# Work Order ID 94820

Item Name: Basket Hoop

DRAWING NO. D3166	TITLE BASKET HOOP	REV A1	DART AEROSPACE LTD ENGINEERING ORDER		D.E.O. NO. D3166-A-2	SHEET NO. 1 OF 1	SCALE NTS
DRAWN AJS	CHECKED <i>[Signature]</i>	MFG. APPR. <i>[Signature]</i>	APPROVED <i>[Signature]</i>		DE APPR. <i>[Signature]</i>		
DATE 08.12.11	DATE 08.12.15	DATE 08/12/15	DATE 08/12/16		DATE 08.12.16

DESIGN #	DRAWN BY CP	DART AEROSPACE LTD HAWKESBURY, ONTARIO, CANADA	
CHECKED #	APPROVED #	DRAWING NO. D3166	REV. A SHEET 1 OF 1
DATE 02.07.10		TITLE BASKET HOOP	SCALE NTS
A	02.07.10	NEW ISSUE	
A1	04.04.08	38+/-1 WAS 36.0

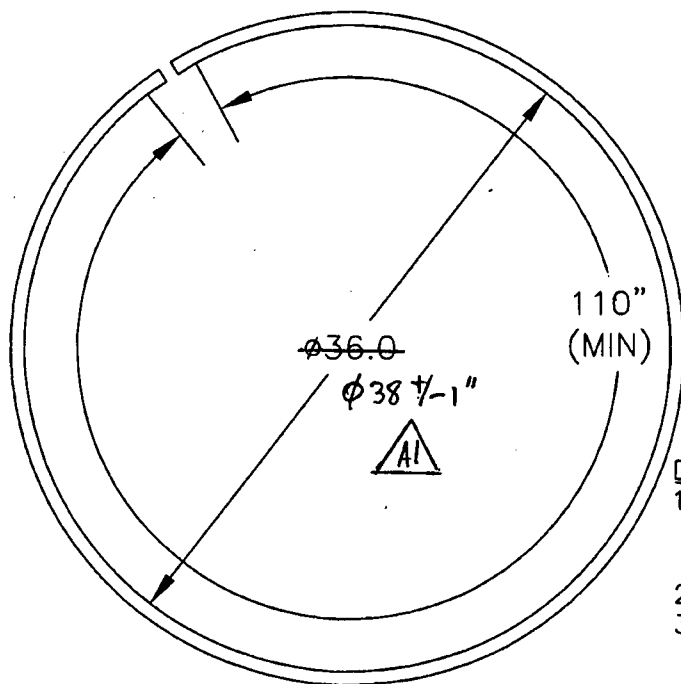
1) MODIFY MATERIAL NOTE FOR D3166-1 AS SHOWN:

IS:

WAS:

1) MATERIAL: AISI 304/316 SS SQUARE TUBING,  
0.75" x 0.75" x 0.063 WALL, 60.00" LONG  
(REF DART SPEC. M304TS0.750W.063)

2) MODIFY MATERIAL NOTE FOR D3166-3 AS SHOWN:

WAS:

1) MATERIAL: AISI 304/316 SS SQUARE TUBING,  
0.75" x 0.75" x 0.063 WALL, 120.00" LONG  
(REF DART SPEC. M304TS0.750W.063)

1) MATERIAL: AISI 304/316 SS, 3/4 X 3/4 X 0.065 WALL SQUARE TUBING,  
60.00" LONG  
REF. DART SPEC M304TS0.750W.065

1) MATERIAL: AISI 304/316 SS, 3/4 X 3/4 X 0.065 WALL SQUARE TUBING,  
120.00" LONG  
REF. DART SPEC M304TS0.750W.065
